Diagram 2: Source Google maps

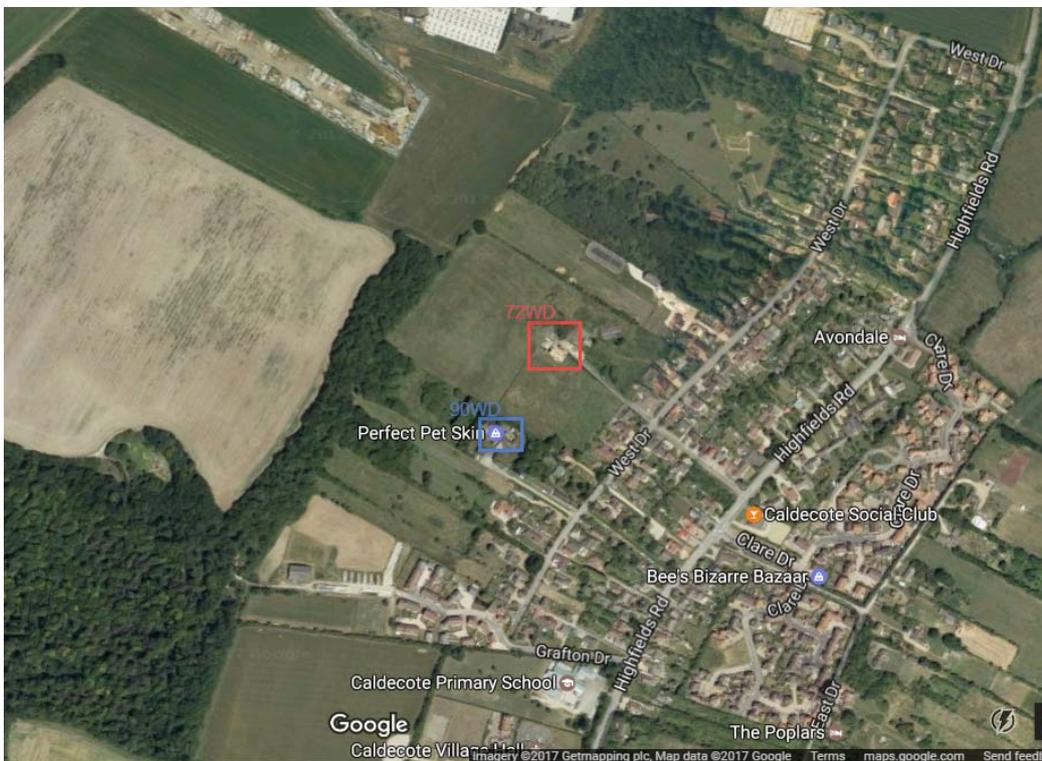
The diagram above purports to show 390m as the longest separation, but it ignores the properties at No. 72 West Drive and No. 90 West Drive which are outside the village development framework, making the separation more like 200m to those properties. These are shown for clarity in the Diagram 2 below. No. 72 in red and No.90 in blue.
